METROPOLITAN GOVERNMENT OF NASHVILLE AND DAVIDSON COUNTY

STAFF RECOMMENDATION
2218 Grantland Avenue
March 17, 2021

Application: New Construction—Addition
District: Woodland in Waverly Historic Preservation Zoning Overlay
Council District: 17
Map and Parcel Number: 10514011200
Applicant: Brittney Blanton, Architect
Project Lead: Sean Alexander, sean.alexander@nashville.gov

Fig. 2: Existing addition wraps the rear-right corner of the house.

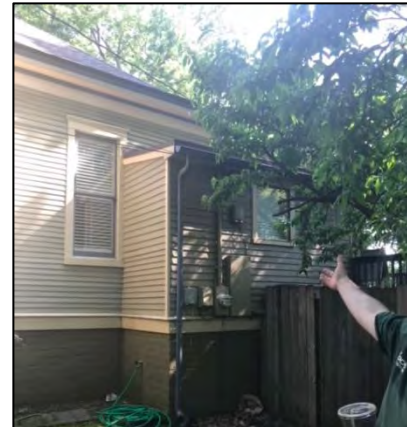
Demolition: Portions of the rear wall and the rear slopes of the roof will be removed to accommodate the proposed new rear addition. An earlier addition that wraps the right-rear corner of the house will also be removed. The elements on the rear of the building are not visible and therefore do not contribute to the historic character of the house. The earlier addition on the right is more visible, but it is not historic and does contribute to the historic character.

Staff finds that the proposal meets demolition meets Section V.B.2 for appropriate partial demolition.

SITE PLAN
 scale: 1" = 10'-0"

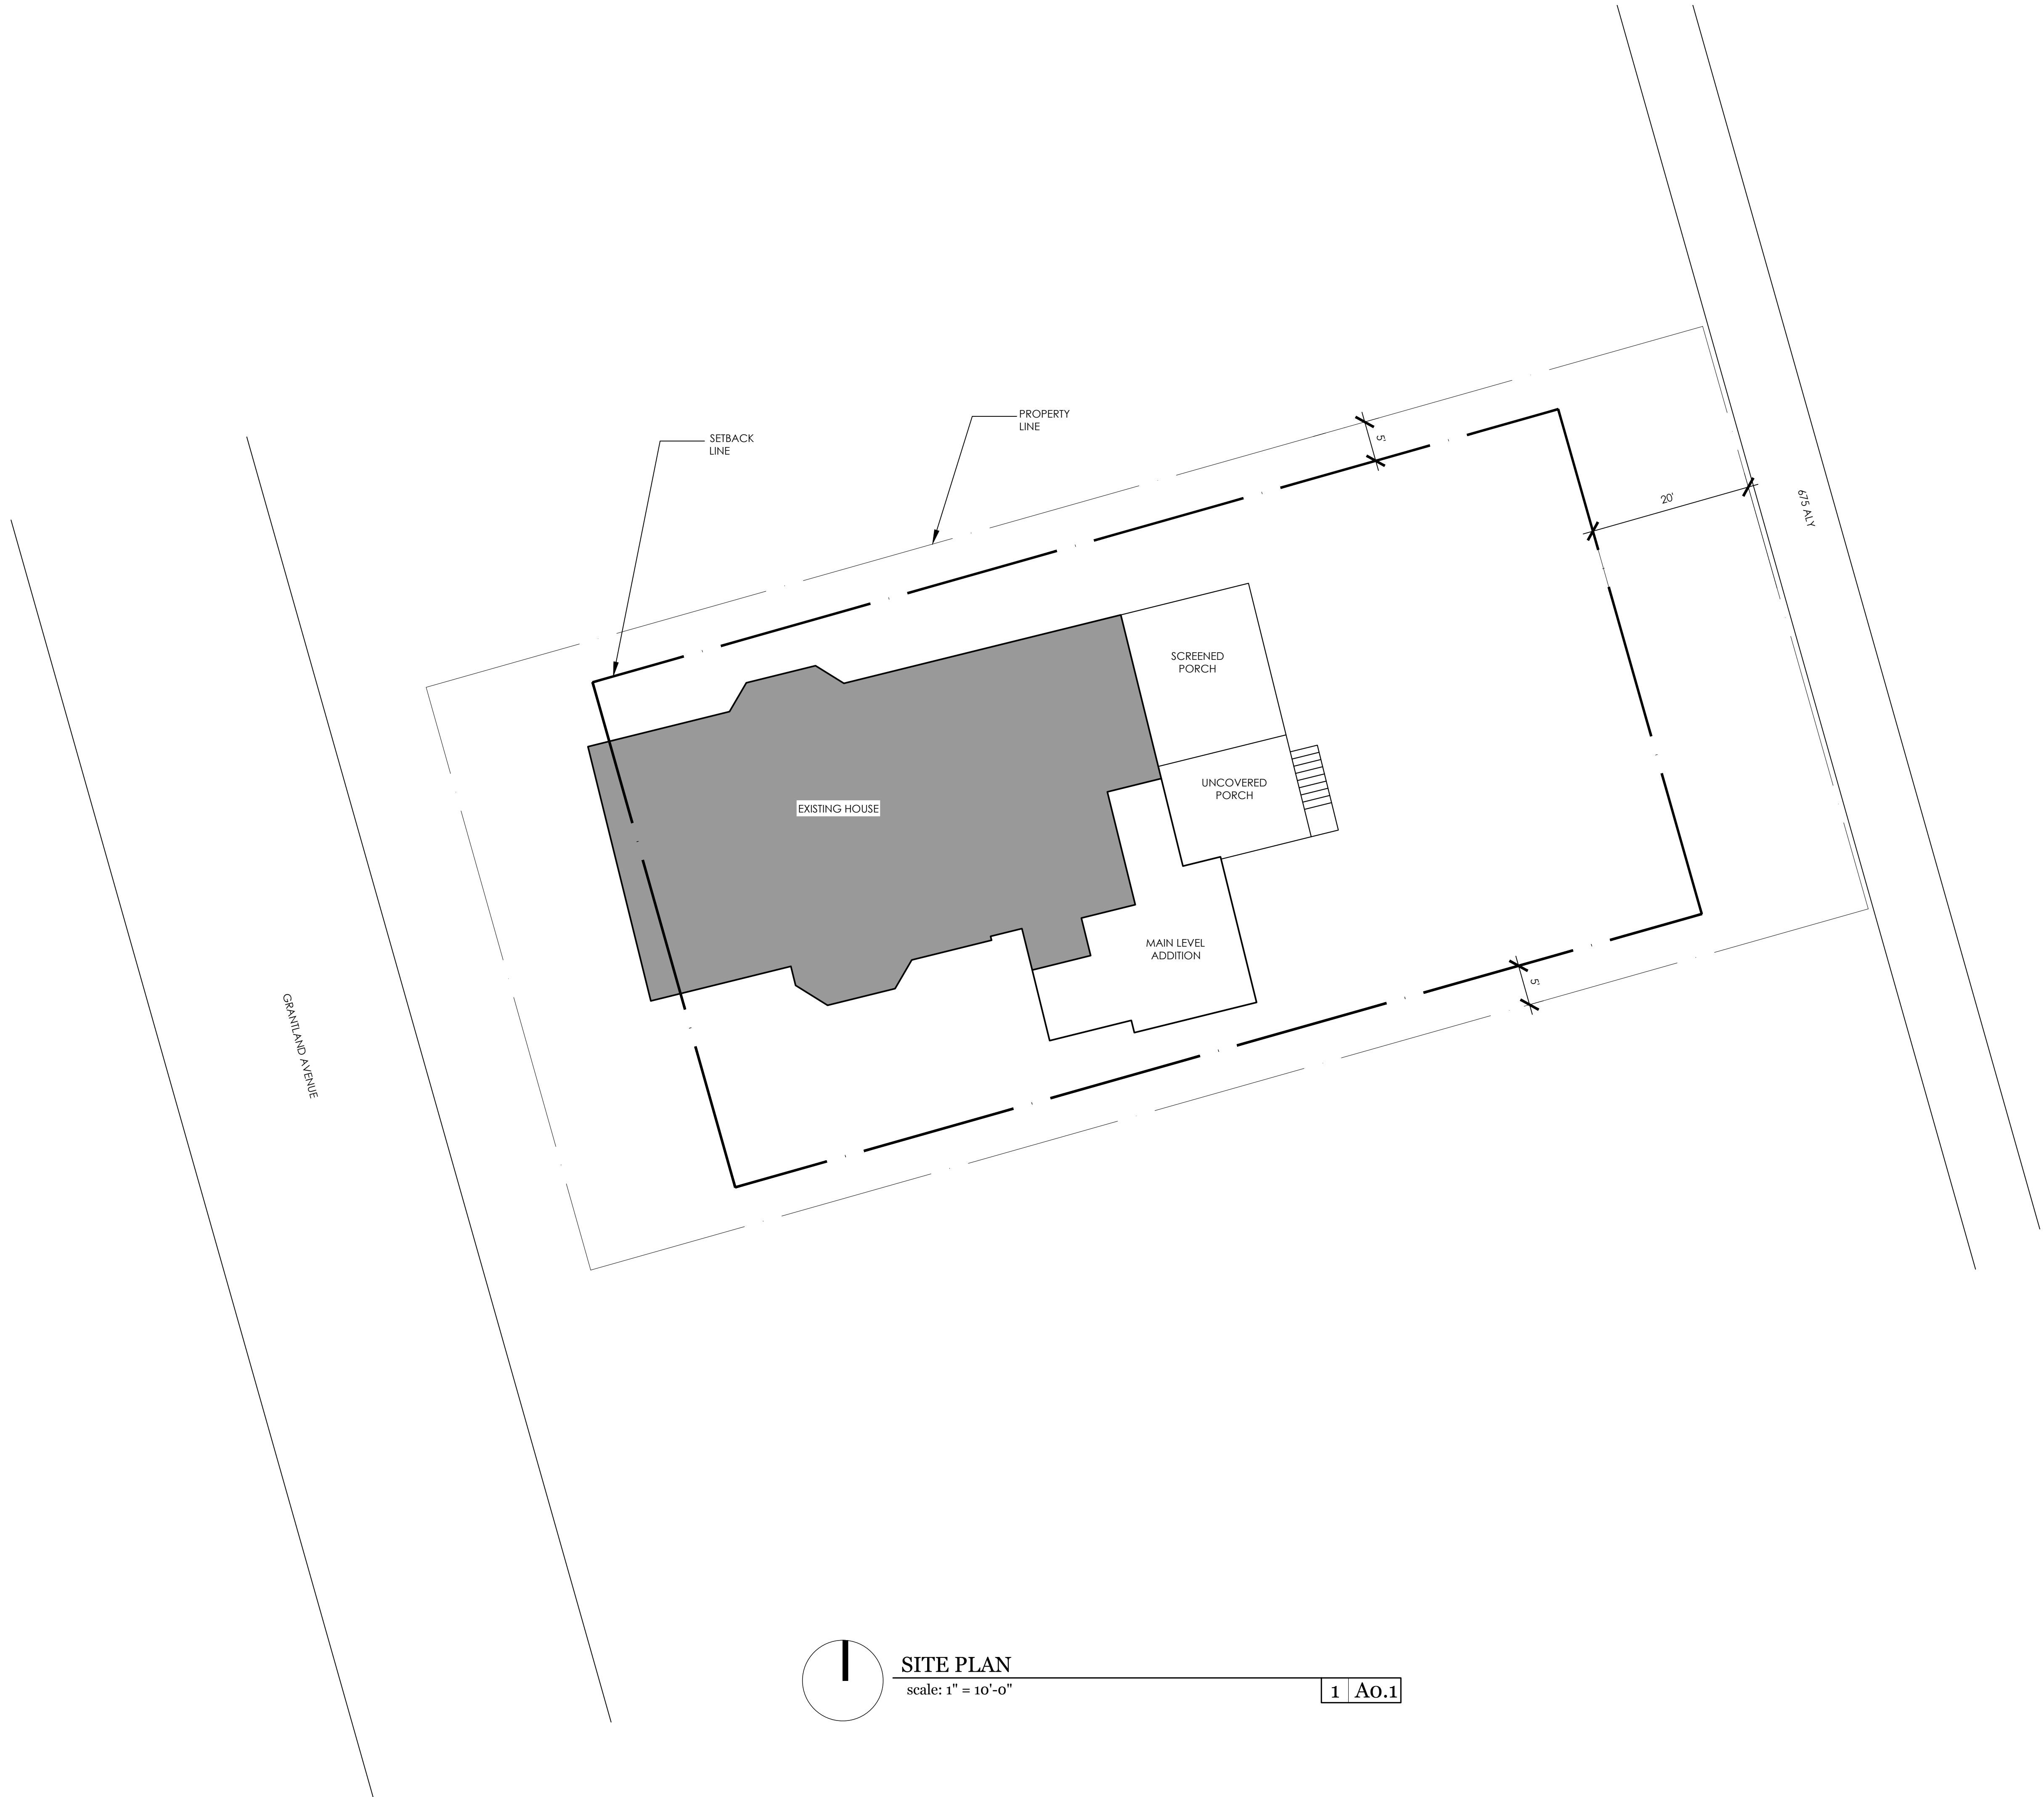
Setback & Rhythm of Spacing: The addition will match the existing setback on the house on the left and will have a right-side setback of ten feet (10'). The rear setback will be sixty-five feet (65'). These setbacks are consistent with the setbacks on surrounding historic houses.

Staff finds that the setbacks of the proposed addition are appropriate and meet Section III.B.2.c of the design guidelines.
